Date:	30 August 2024	Application Number:	LU-2023-112110-00; SG-2023-112111-00; NC-2023-112112-00
Reporting Planner:	Sarah Exley	Site Visit on:	11 th June 2024

Applicant:	NZHG Gisborne Limited
Property Address:	99A Stanley Road, Gisborne
Legal Description:	Lot 1 DP 5799 contained in Record of Title GS3D/818
District Plan:	Te Papa Tipu Taunaki o Te Tairāwhiti – Tairāwhiti Resource Management Plan
Zoning:	General Residential
Other Restrictions:	Land Overlay 1; Reticulated Services Boundary; Stanley Road – Principal Road
Activity Status:	Discretionary
Proposal:	Bundled Land Use and Subdivision consent to enable an 8-unit housing development

Report to Hearings Commissioner

Figure 1. Elevations; red indicates height recession plane infringements on boundaries. Some are duplex boundaries and so not applicable. Yard infringements not shown.

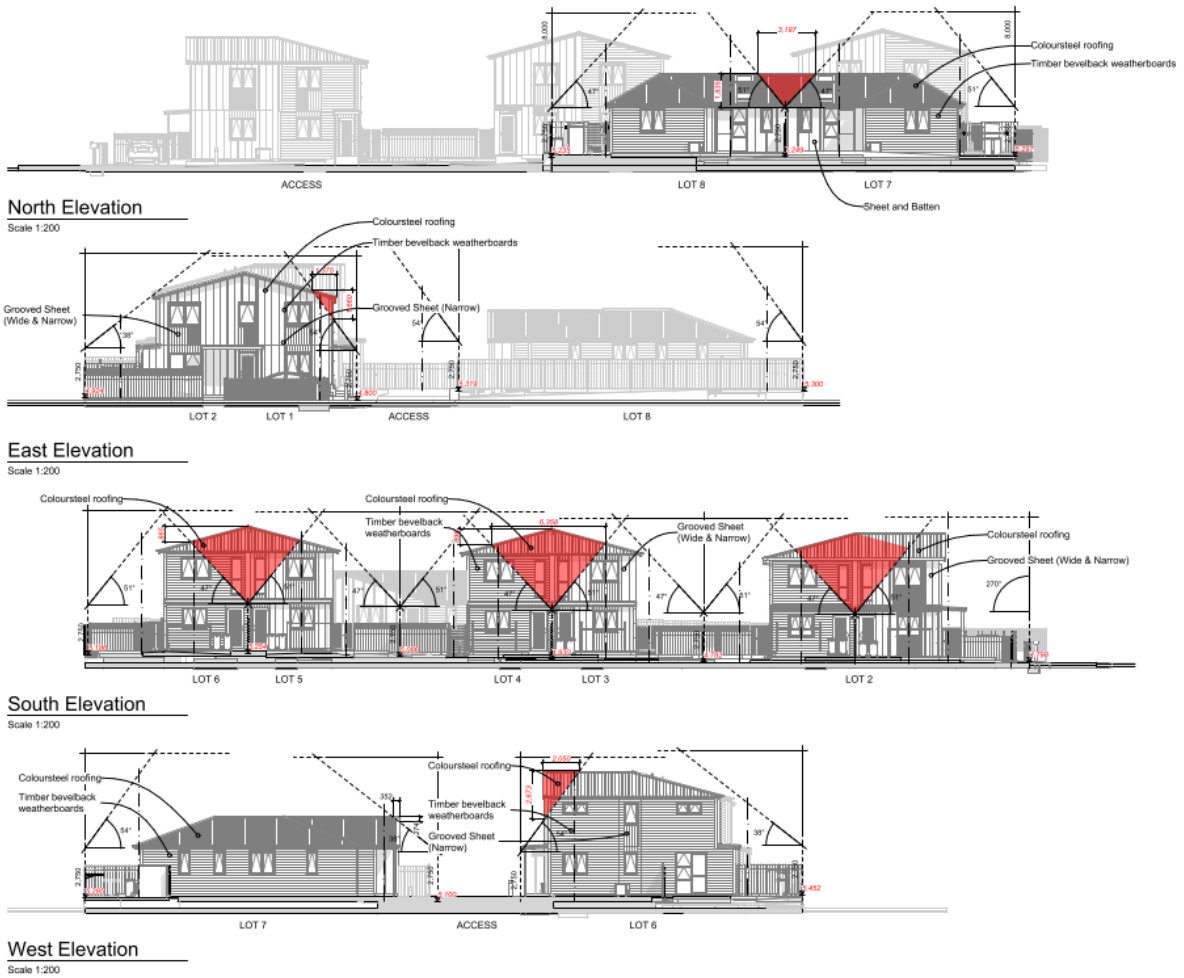
- Unit 6 as it relates to the JOAL boundary by a height of 2.6m for the length of the dwelling.
111. Furthermore, Units 1 – 6 are located so that their building envelope is maximised to the applicable recession plane with the southern boundary of 495-501 Childers Road. The

116. The Applicant has stated that "*the proposal does not result in unreasonable overlooking of boundaries.*"¹⁰ I disagree with this as the reduced yard setbacks and breached recession planes mean rooms do overlook into the shared JOAL, especially from upper stories into other property windows and outdoor areas, as demonstrated by the below elevation plans in Figures 1 and 2.

118. However the infringed recession planes reduce privacy and amenity for users in the manner an individual access would. This would be most notably felt by residents of Units 7 and 8 (single-storied), considering the substantial infringements on the JOAL (1.1m and 2.6m heights) caused by opposite Units 5 and 6 (double-storied).

Figure 4. Site (blue boundaries) in proximity to public reserves (green) and public schools (orange).

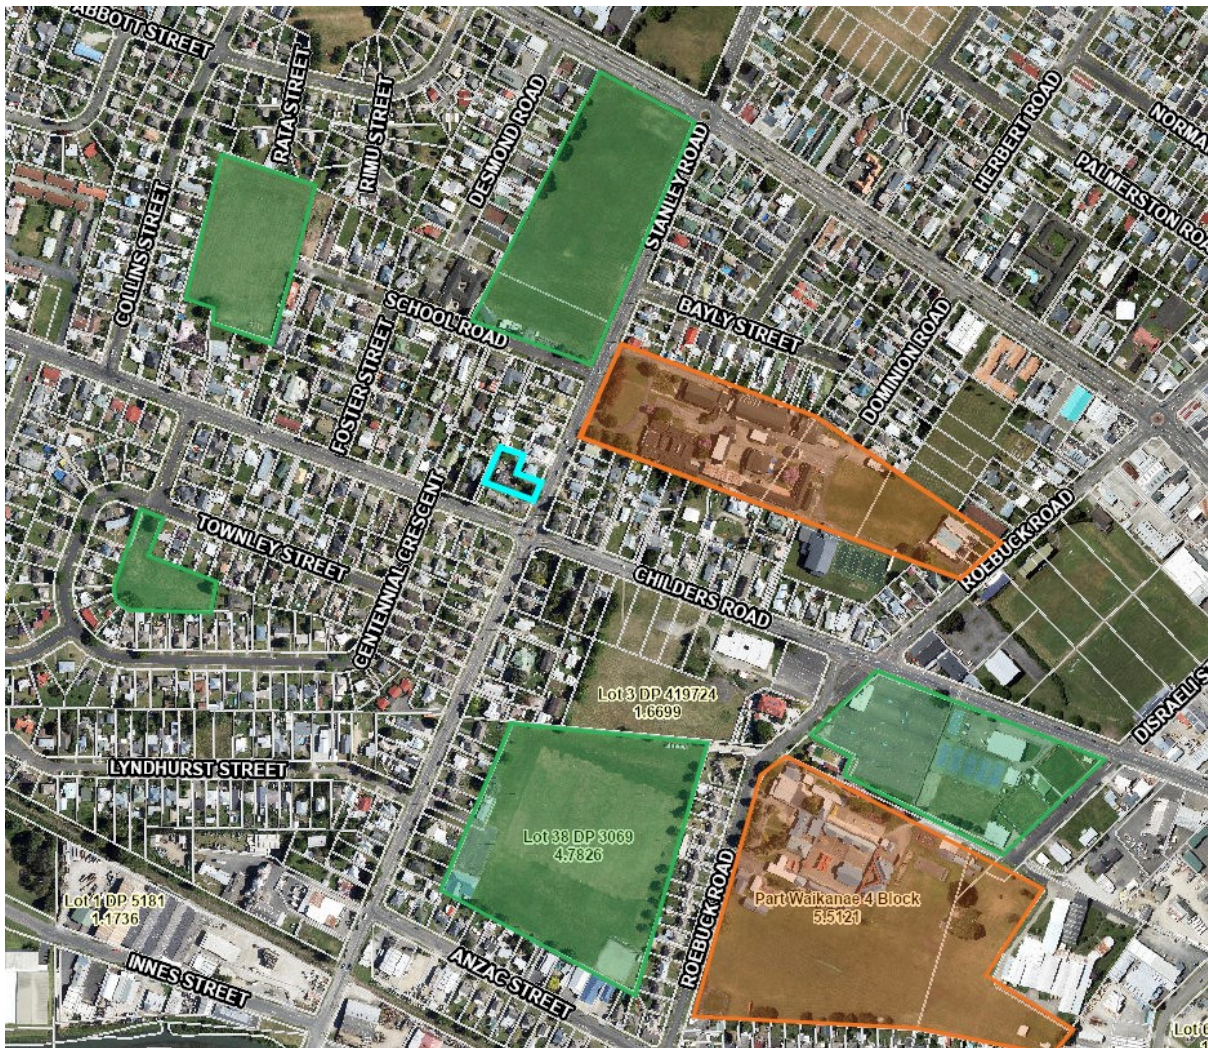
164. I note both pedestrians and vehicle users are required to cross a main road or intersection to access the Oval Reserve (no playground equipment), Netball Courts and Centennial Crescent Park. While a walking distance of 180m to the closest local 'open' space (rugby field) may be considered to be reasonable walking access to public or communal recreational space, I note that all of the above are sports fields without amenity planting, shelter, tables or seating, and no playground equipment. I consider there are no other public amenity reserves within a reasonable walking distance to the site.

165. The above distances and the image below shows the site location is inappropriate for the effects of high-density are not mitigated by proximity to neighbourhood reserves or recreation areas.
